**Re: Addendum No. 1  
SOM Center Sidewalks  
City of Willoughby**

Date: May 30, 2024

**SOM CENTER SIDEWALKS**  
RIDGE ROAD TO EUCLID AVENUE  
- WILLOUGHBY, OH 44094 -  
**CONSTRUCTION DETAILS - 3**

PROJECT NO.	230135-05
DISCIPLINE	CIVIL
SHEET NAME	DET-3
SHEET	25
OF	27

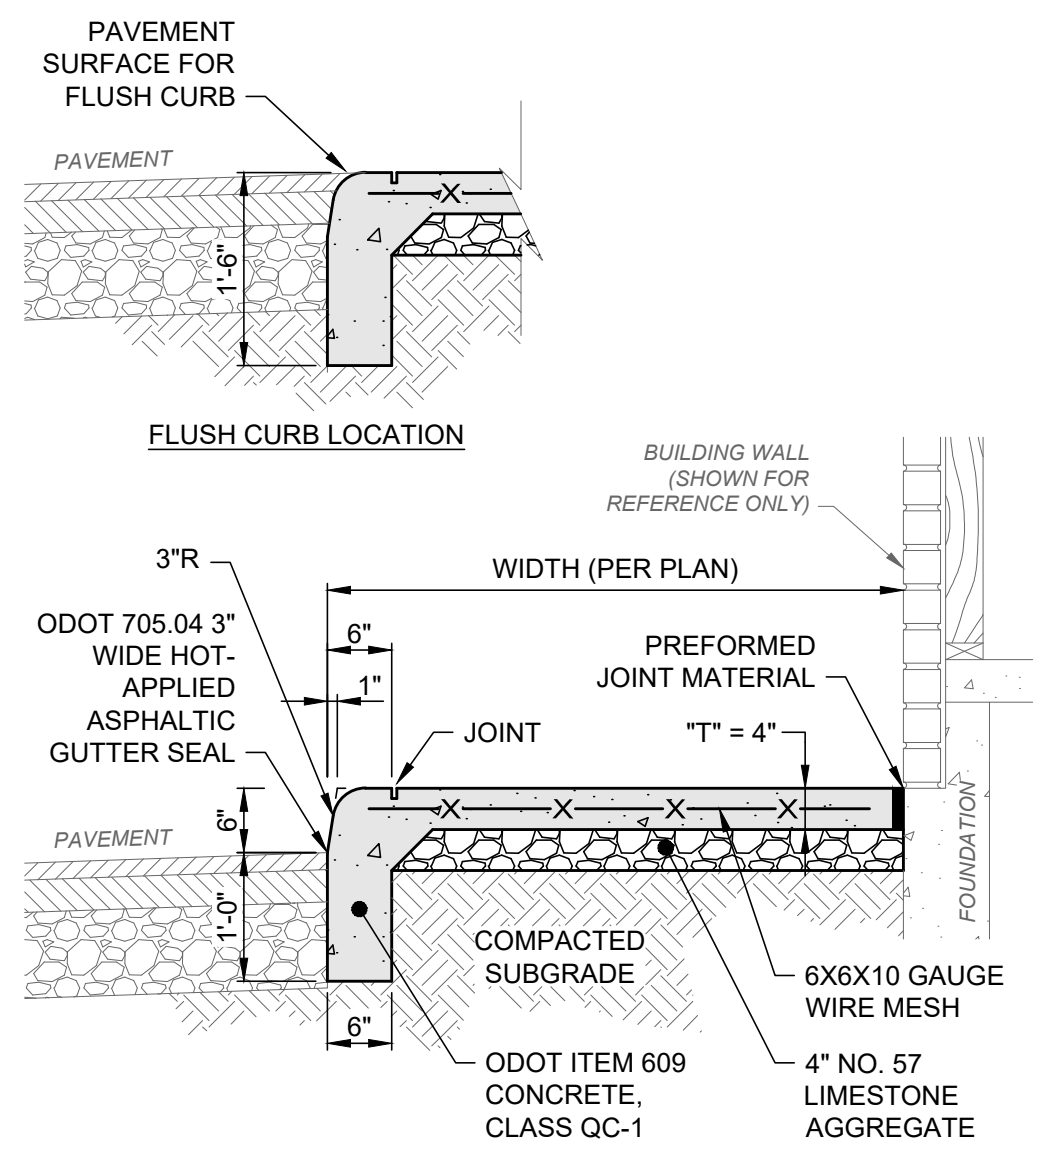
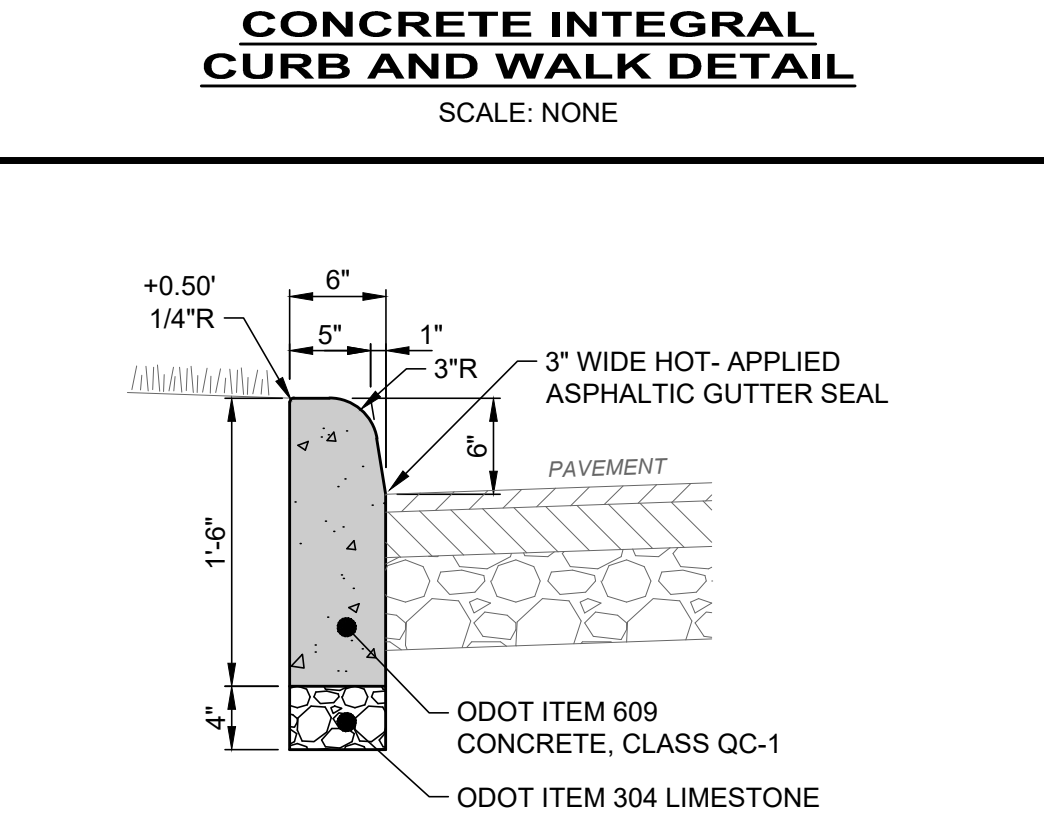
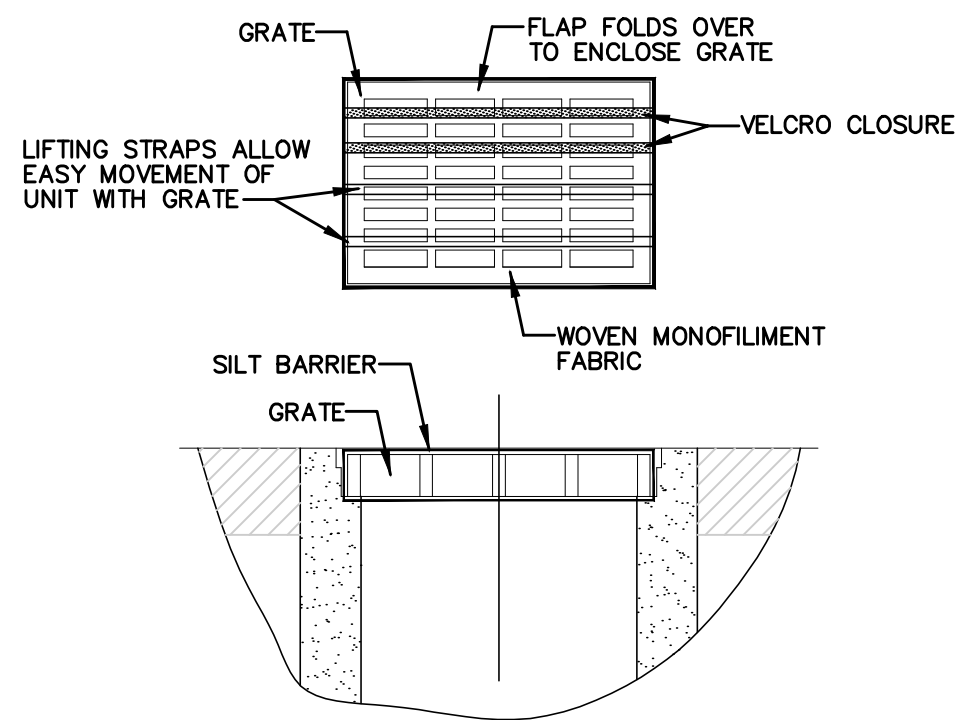
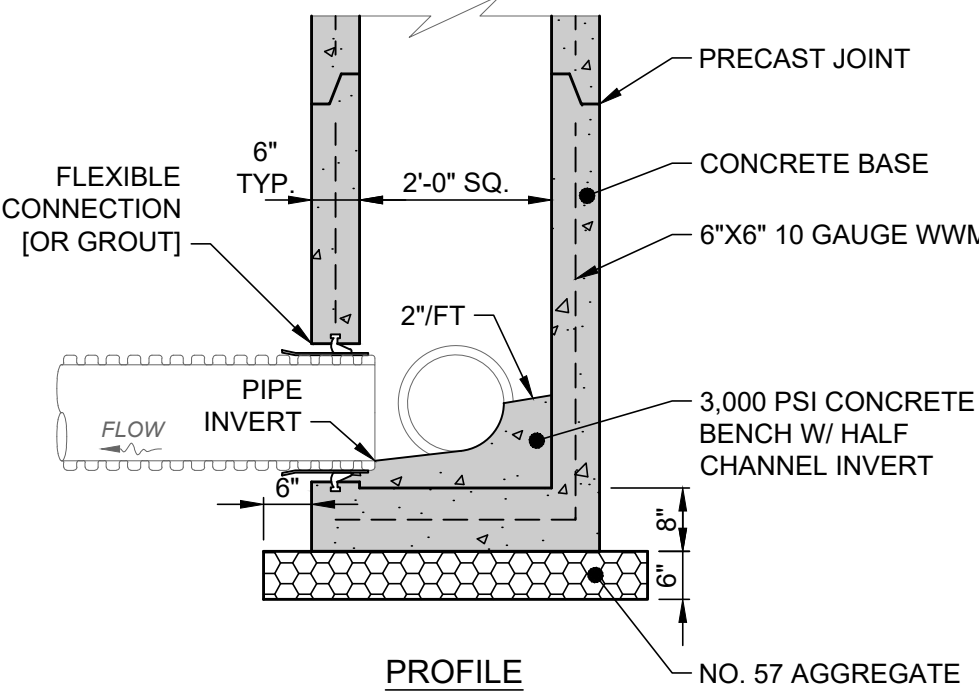
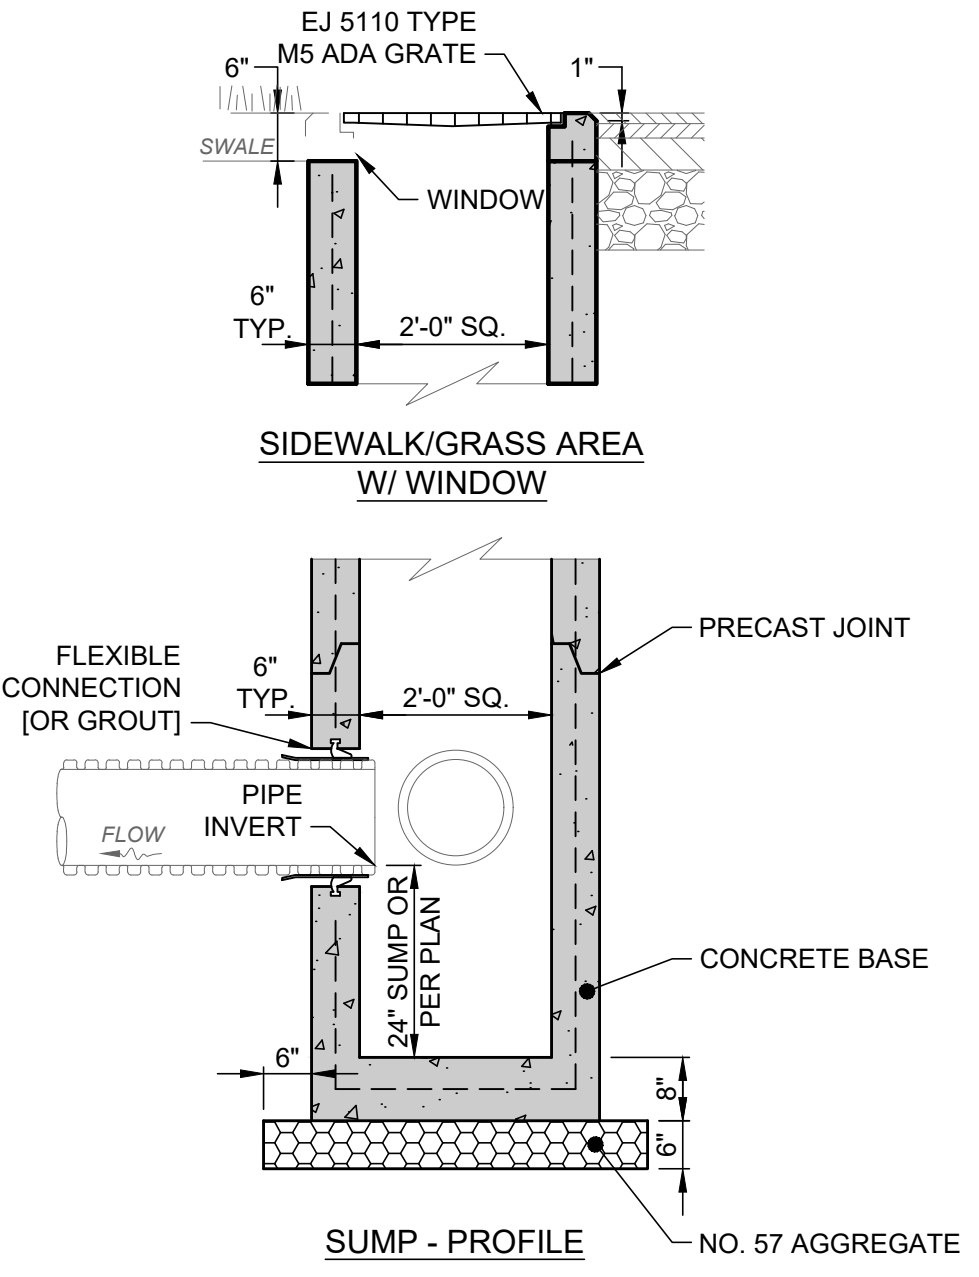
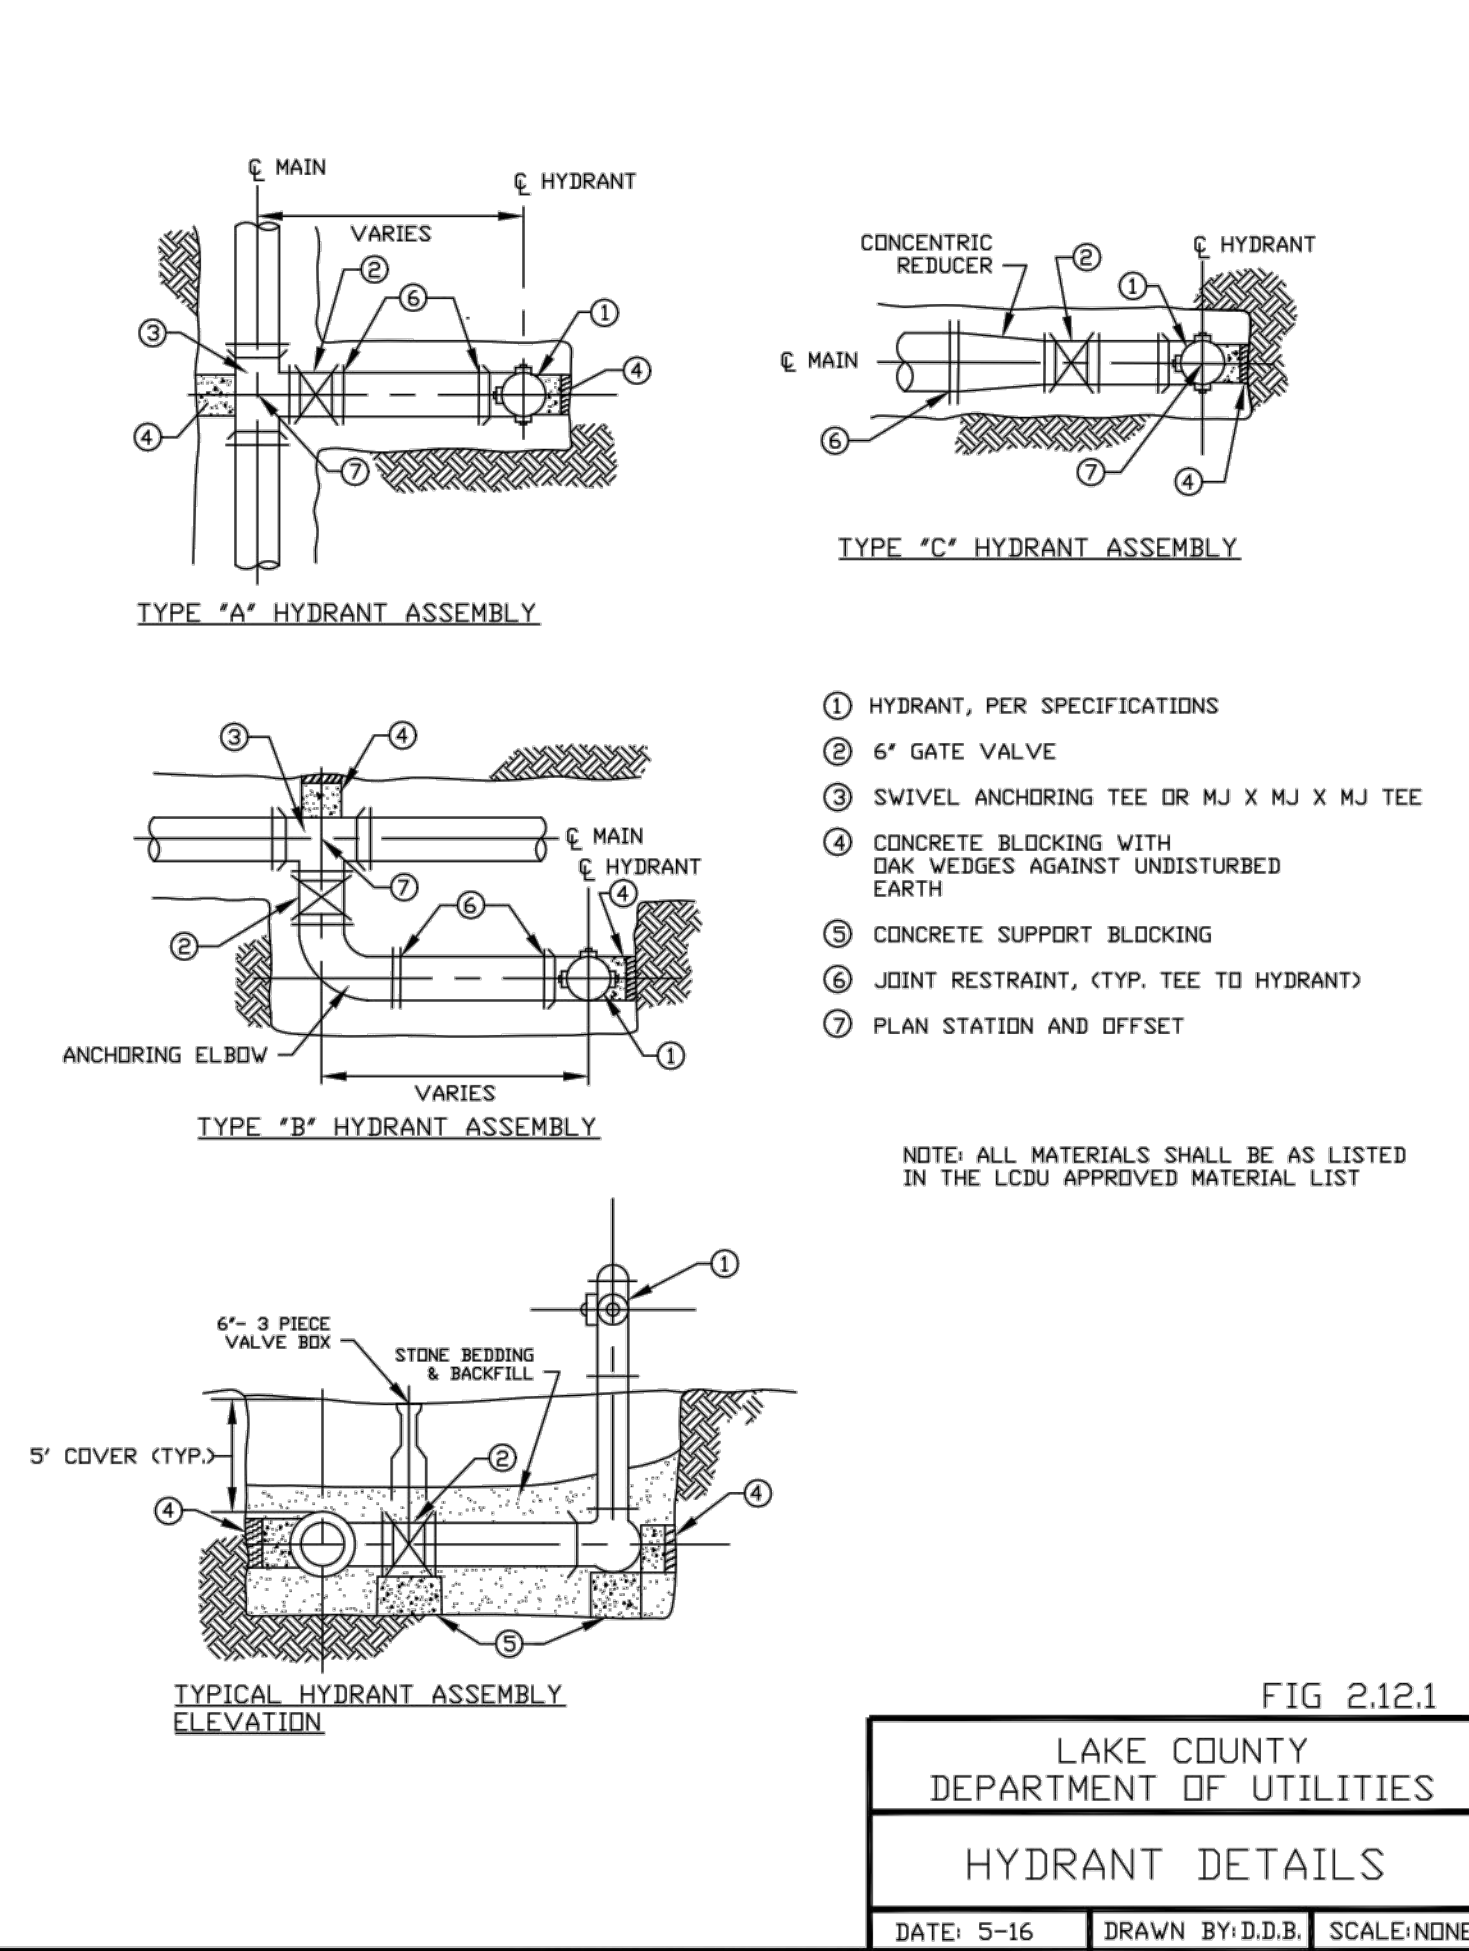
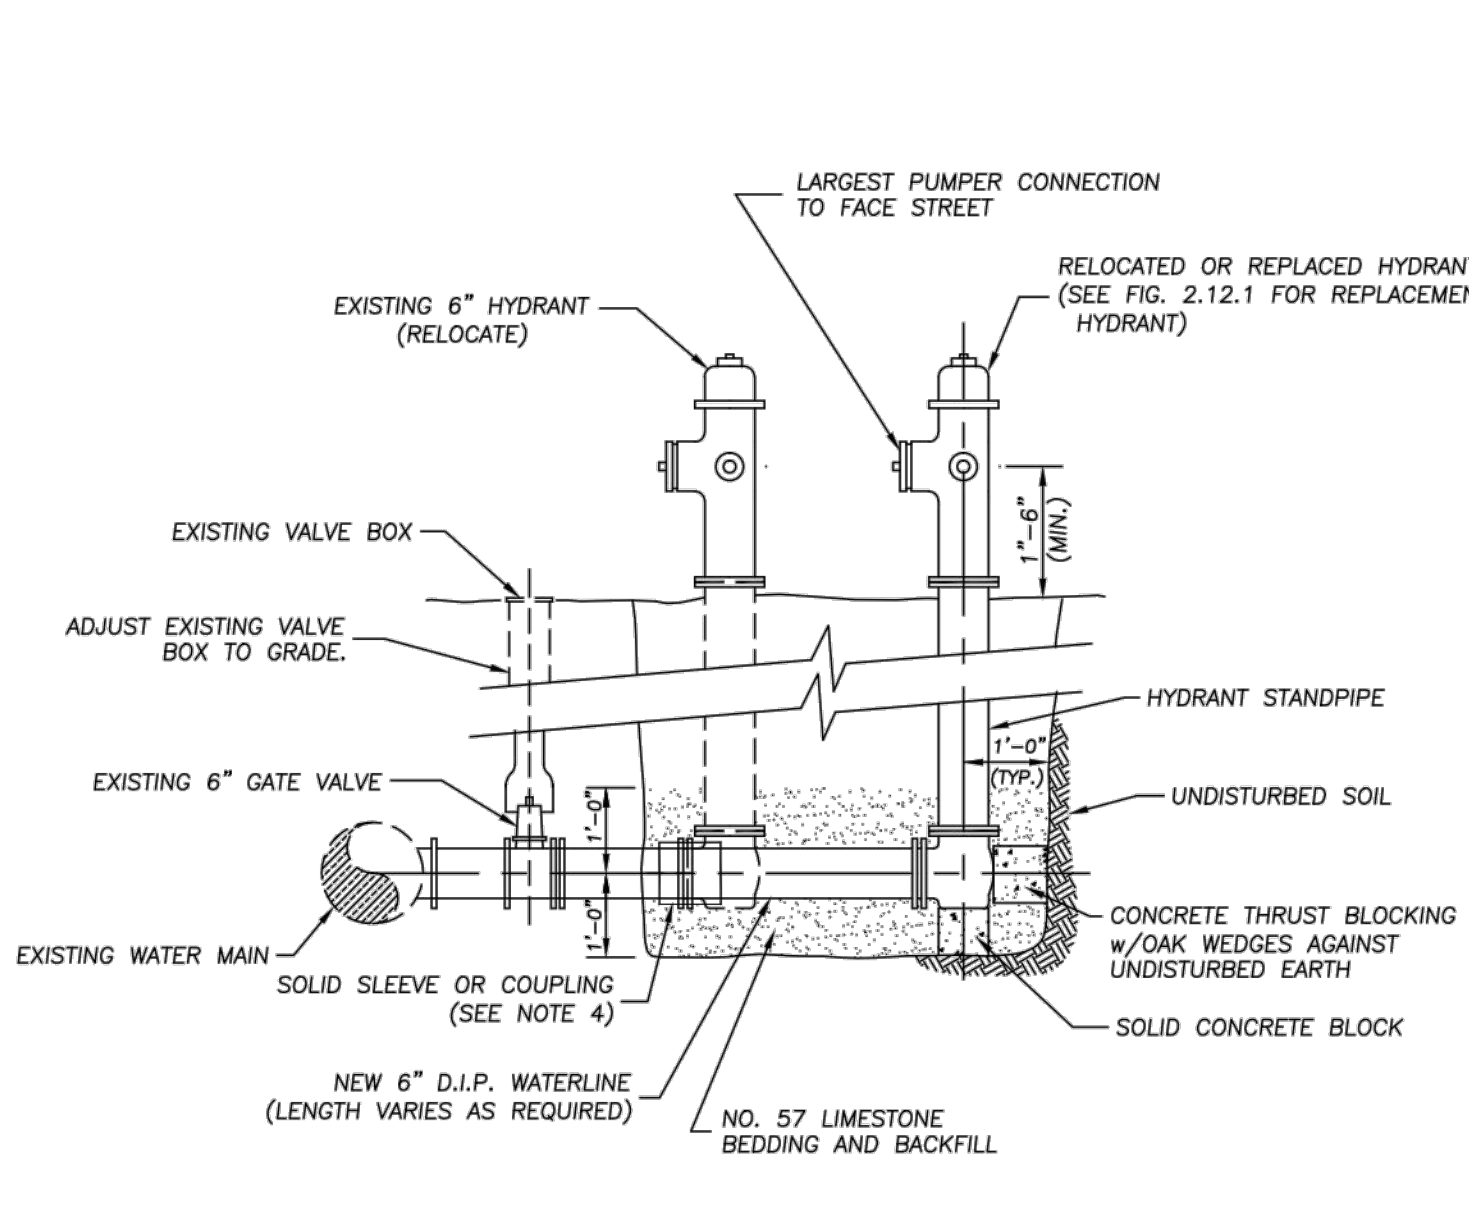
**Replace** plan sheets 23/27 & 25/27 with the enclosed Addendum 1 Revised plan sheets 23/27 & 25/27.

DATE	06/30/24
REVISION	DETAIL UPDATES - ADDENDUM 1
NO	A
